SUBJECT: Initial Drafts of MIL-PRF-23269H, MIL-PRF-23269/1J, MIL-PRF-23269/2J and MIL-PRF-23269/10E
Project numbers 5910-2016-035, 036, 037 and 038.

INCH-POUND
MIL-PRF-23269/2J
DRAFT
SUPERSEDING
MIL-PRF-23269/2H
31 July 2009

CAPACITORS, FIXED, GLASS DIELECTRIC,
(AXIAL WIRE-LEAD TERMINALS), ~~ESTABLISHED RELIABILITY~~,
STYLE CYR15

FIGURE 1. Dimensions and configurations.

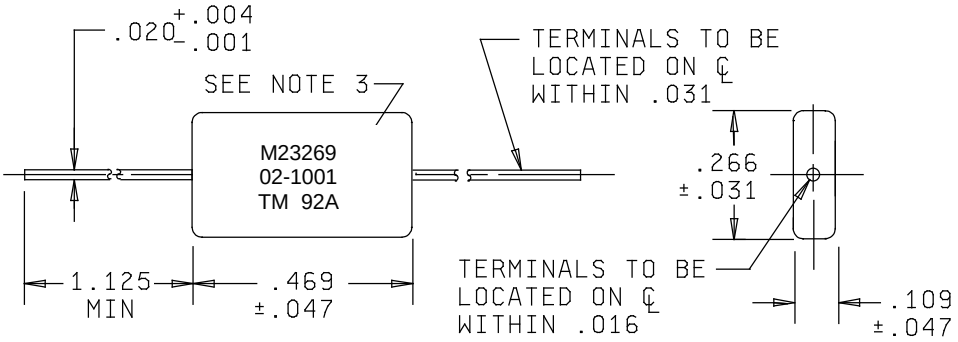
M23269
02-~~3001~~ 1001
TM 09A
